## THE NORTH EDGE 1405 NORTH FEDERAL HIGHWAY APPLICABLE CODES DELRAY BEACH PALM BEACH COUNTY, FL OCCUPANCY CLASSIFICATION

REVISED 12/01/22  
AS PER DEVELOPMENT SERVICES  
COMMENTS:  
1. UPDATED RENDERING AND  
ADDED RENDERING NOTE.

THIS DRAWING IS NOT FOR CONSTRUCTION,  
IT HAS BEEN ISSUED FOR GOVERNMENTAL  
REVIEW AND/OR PRELIMINARY PRICING.

**1 PROPOSED GROUND FLOOR PLAN**  
 SCALE: 1/8" = 1'-0"

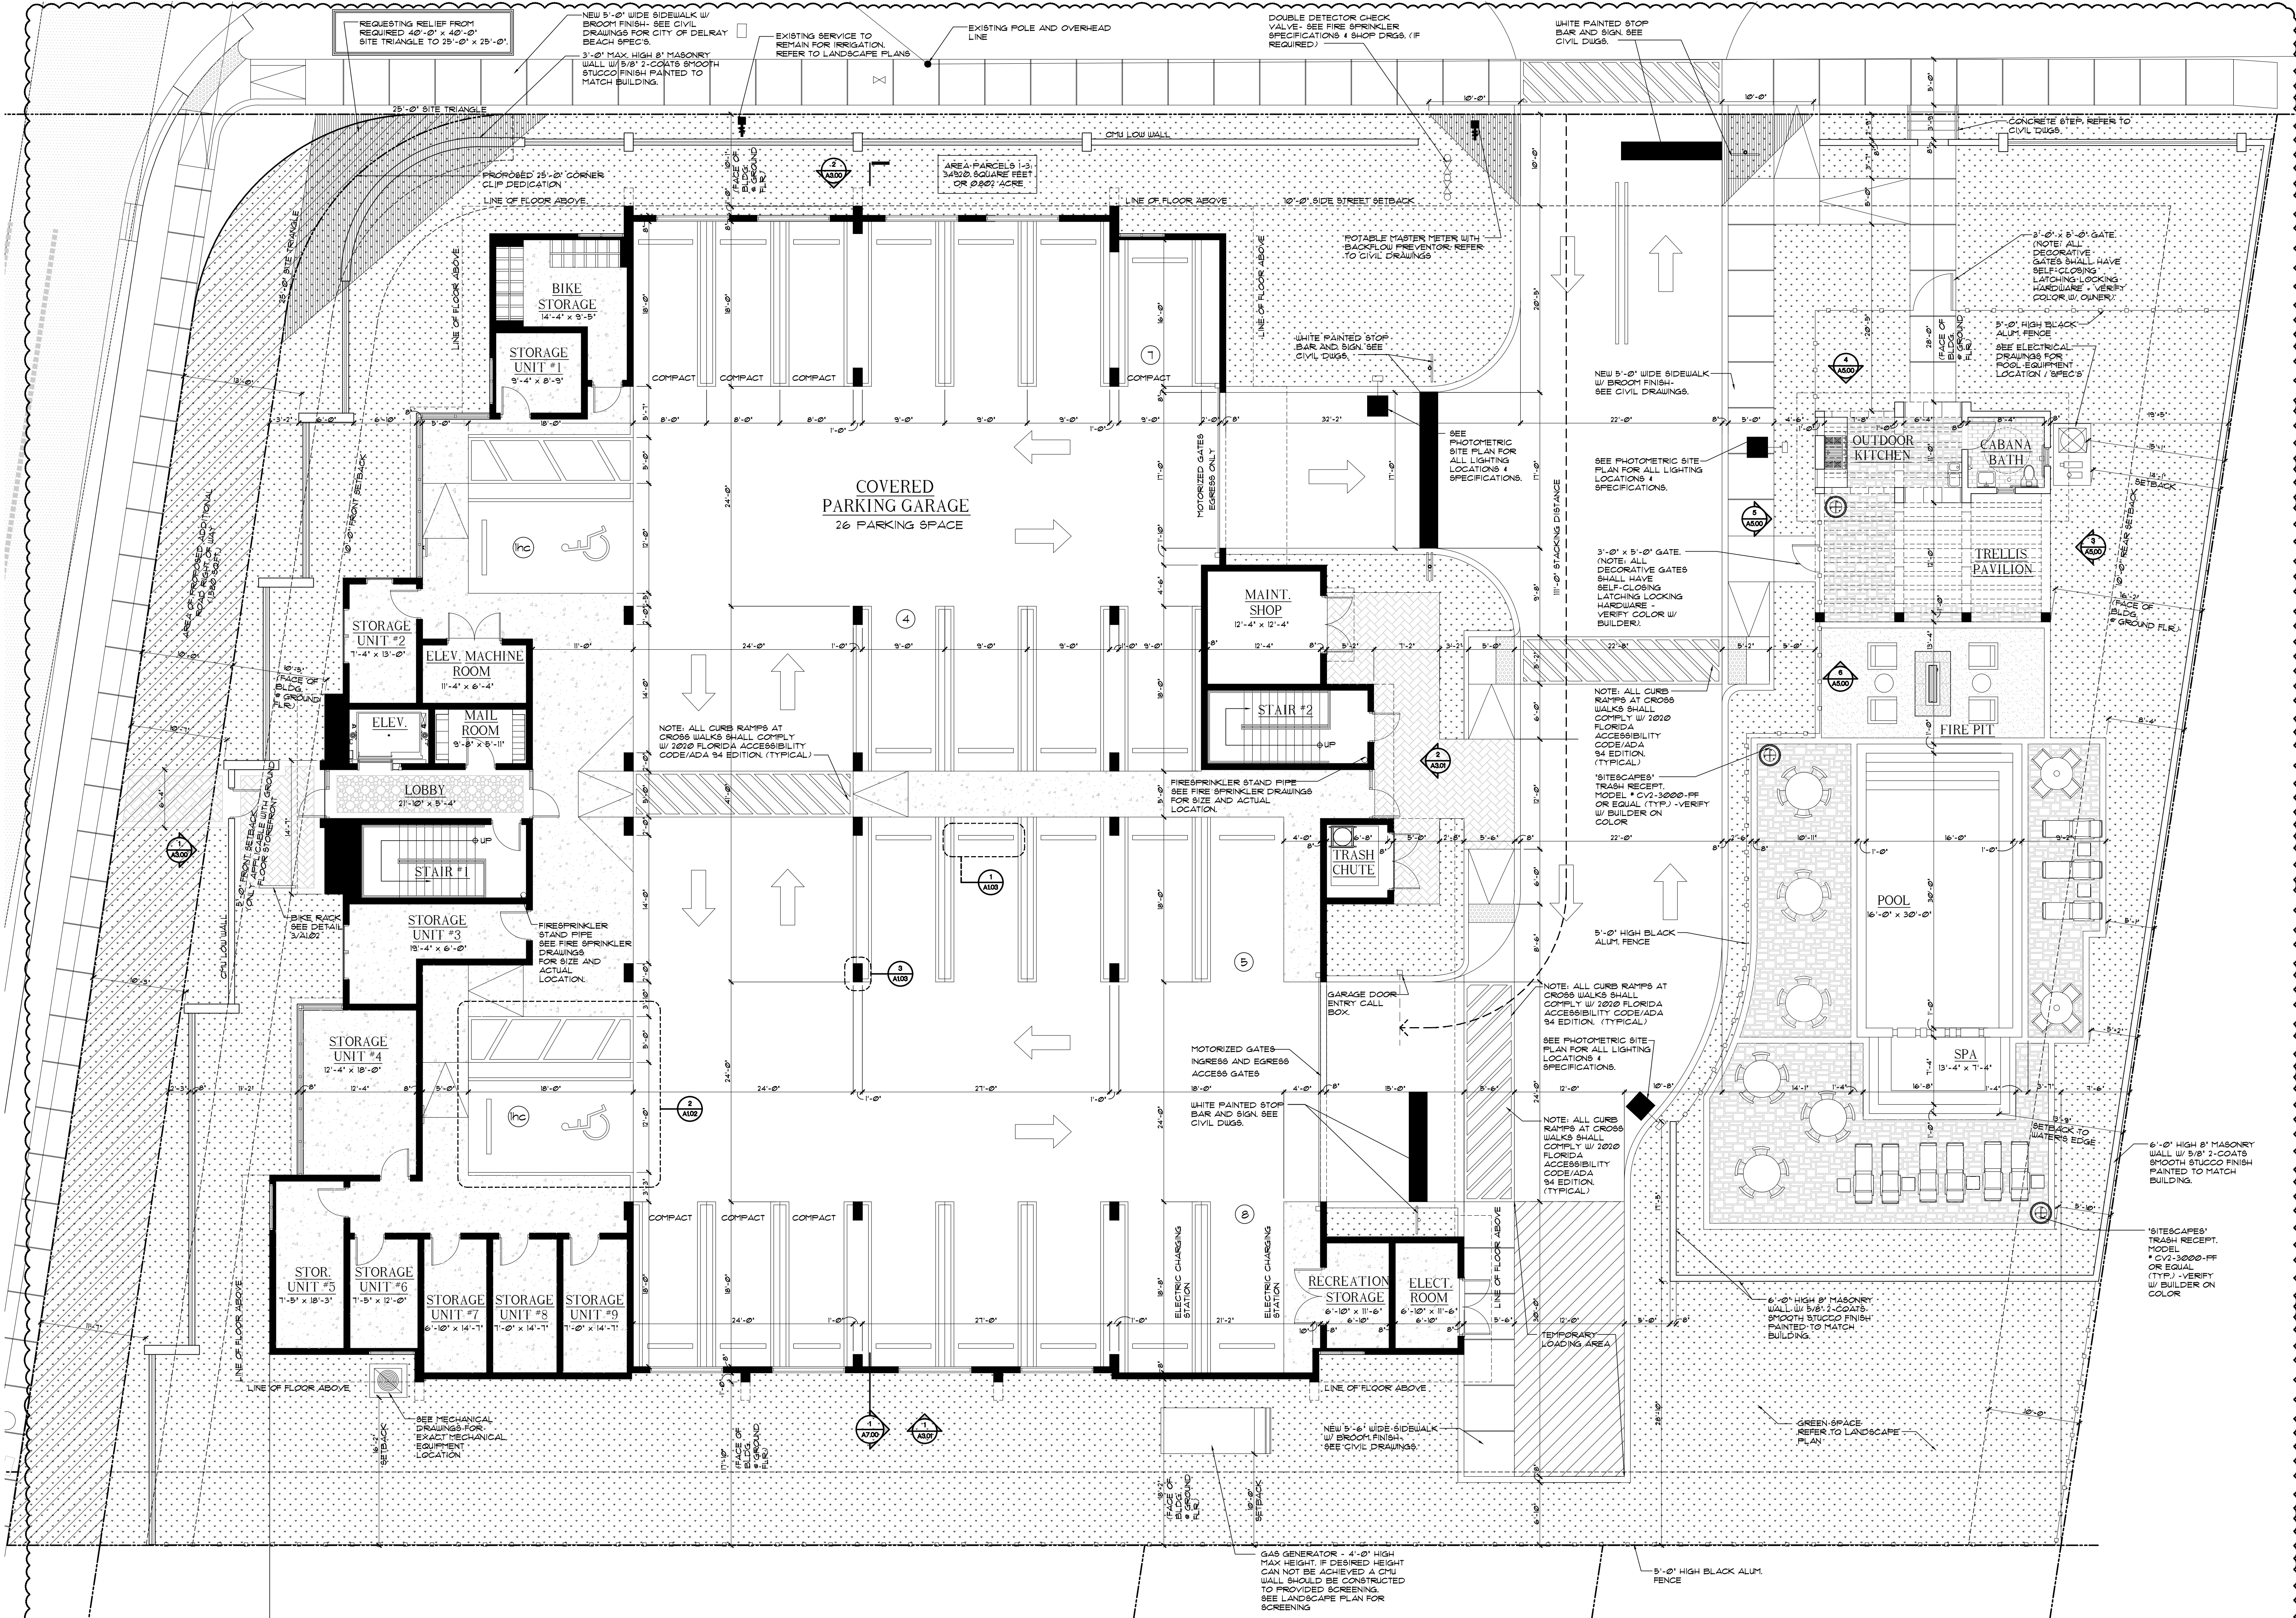
- REVISIONS
- 1. REVISED 12/22 AS PER DEVELOPMENT SERVICES COMMENTS
  - 1. UPDATED FOOTPRINT OF THE BUILDINGS
  - 2. UPDATED PERGOLA TO BE OPEN AIR
  - 3. LABELED GENERATOR HEIGHTS
  - 4. MOVED LOADING ZONE
  - 5. UPDATED AND ADDED CROSSWALK AND SIDEWALK
  - 6. UPDATED NORTH DRIVE TO BE 11'-0" WIDE AND ADDED ONE WAY ARROW.
  - 7. ADDED ADDITIONAL DIMENSIONS TO PLAN
  - 8. UPDATE PLAN FOR STAIR #2 NEW LOCATION

**1 A2.01 PROPOSED SECOND FLOOR PLAN**  
SCALE: 1/8" = 1'-0"

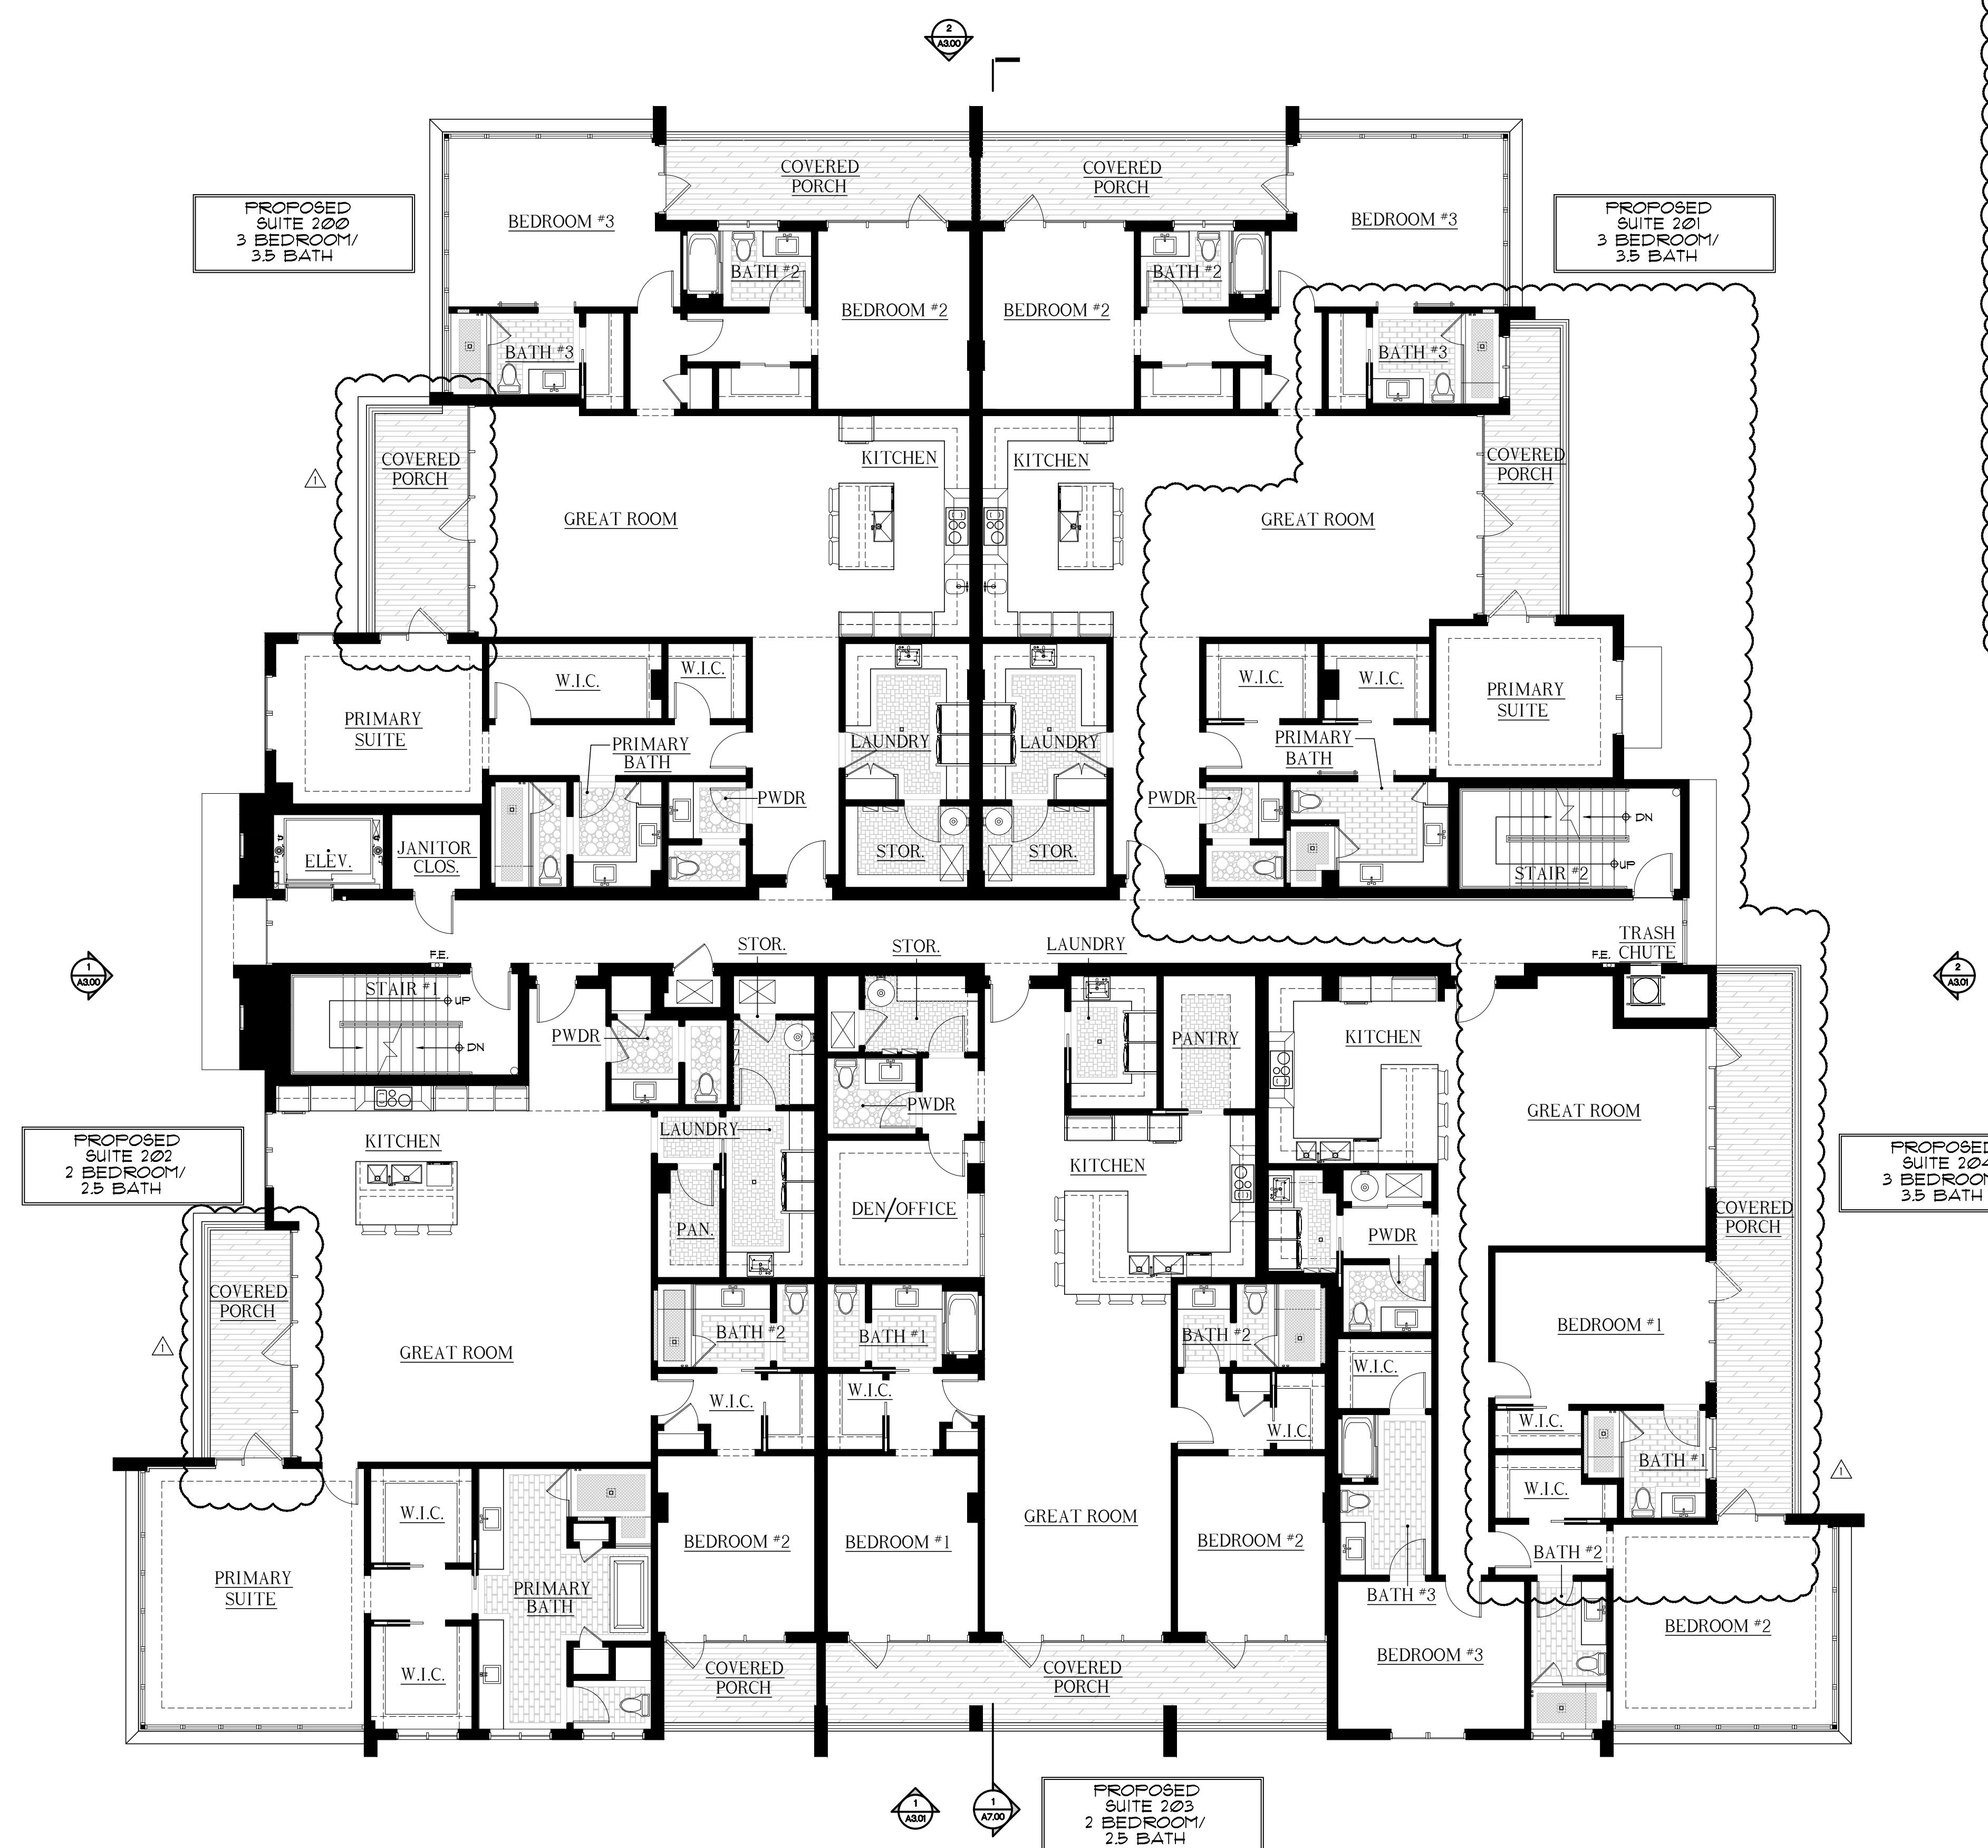
REVISIONS  
REVISOR: 1/23/22  
DATE: 1/23/22  
1. RE-DESIGNED EAST SIDE OF BUILDING FOR NEW STAIRWELL/TRASH CHUTE LOCATION  
2. UNIT 200/202 PORCHES REDUCED IN SIZE  
3. ADDED AREA CHART

**1**  
**A2.02** **PROPOSED THIRD FLOOR PLAN**  
 SCALE: 1/8" = 1'-0"

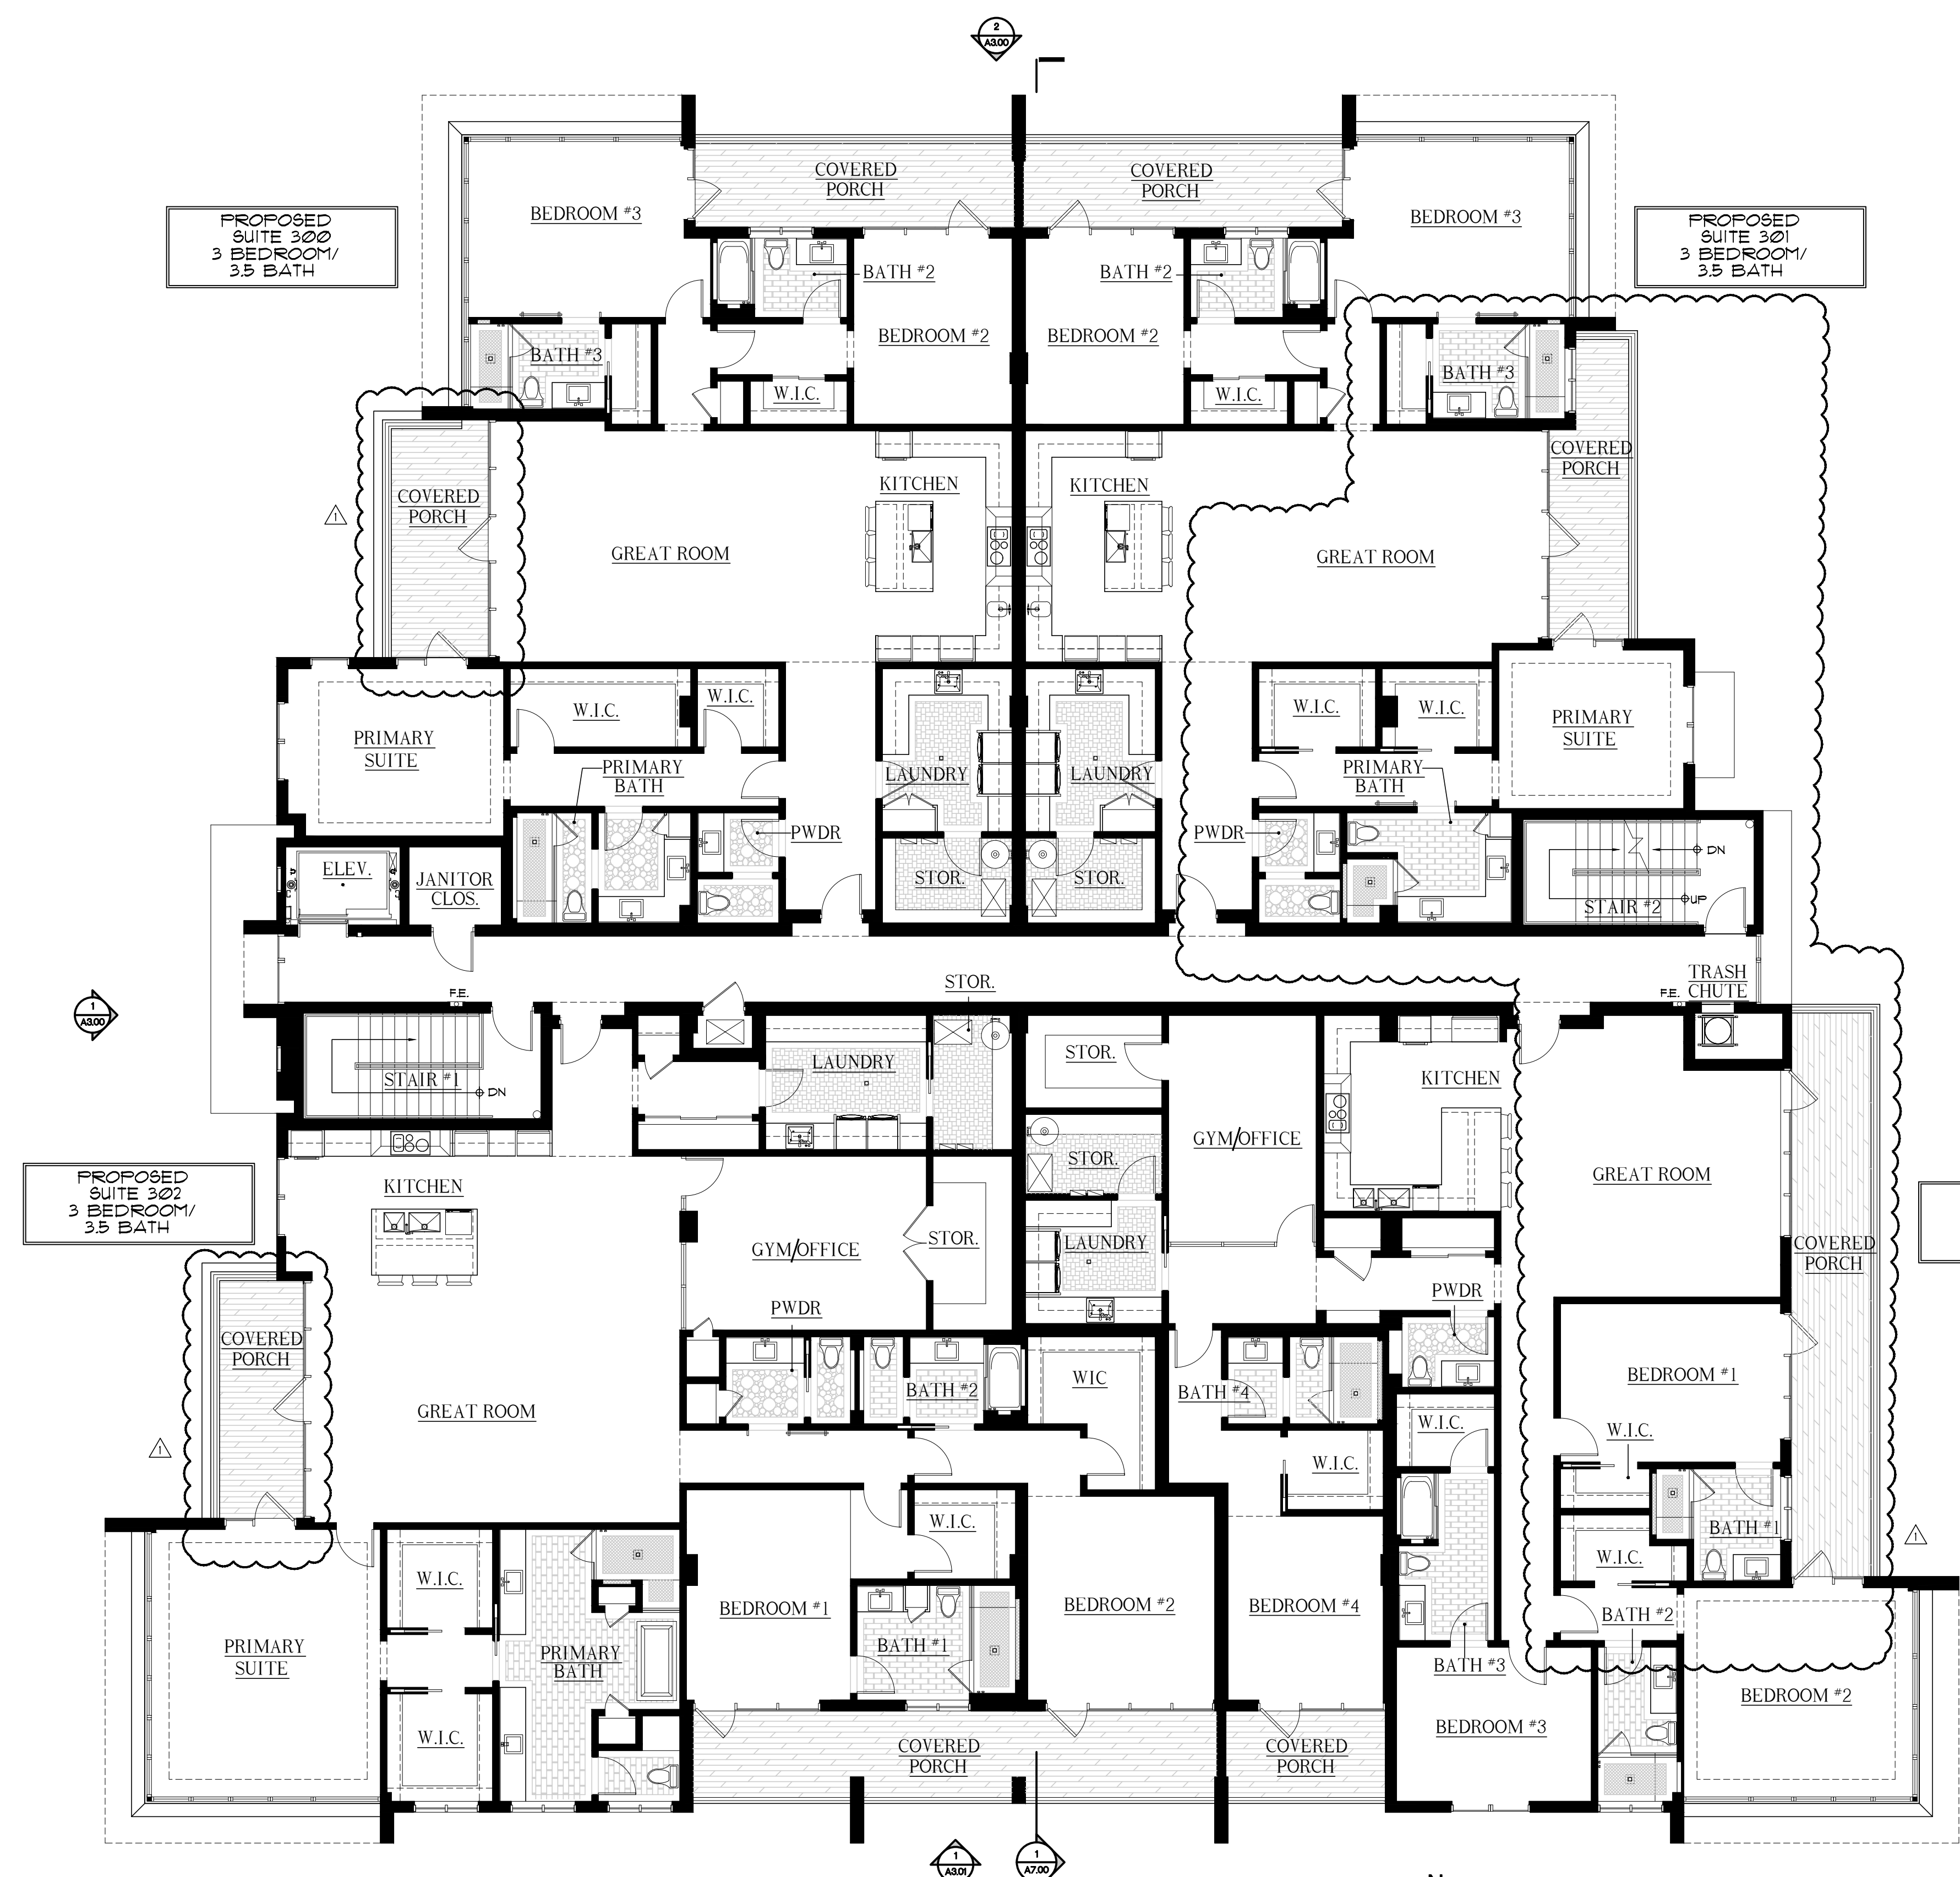
REVISIONS  
 1. RE-DESIGNED EAST SIDE OF BUILDING FOR NEW STAIRWELL/TRASH CHUTE LOCATION  
 2. UNIT 300/301 PORCHES REDUCED IN SIZE  
 3. ADDED AREA CHART
